PRODUCT CHANGE NOTIFICATION

Date: November 06, 2015
PCN: PCN LEDIL 112 a, b, c, d

Subject: PCN 112.b – Change of product mechanical design

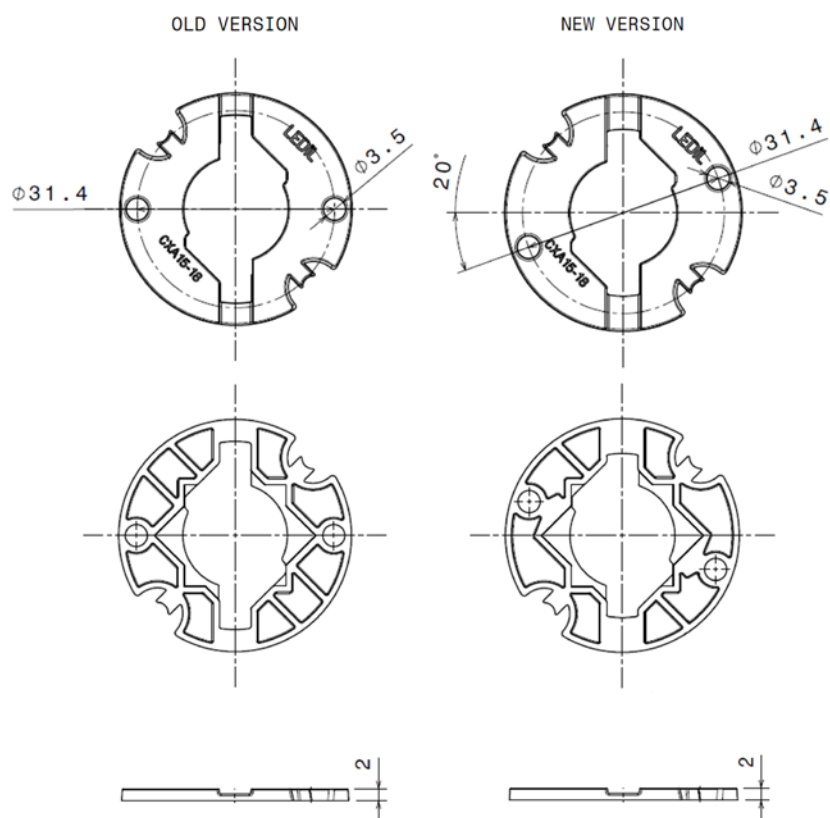
Description: As part of our continuous improvement process regarding the quality of our products LEDiL has moved the screw holes in C14305_STELLA-CLAMP-CXA15-18 to improve mechanical functioning between different COB versions.

Changes: Screw hole positions have been changed accordingly.
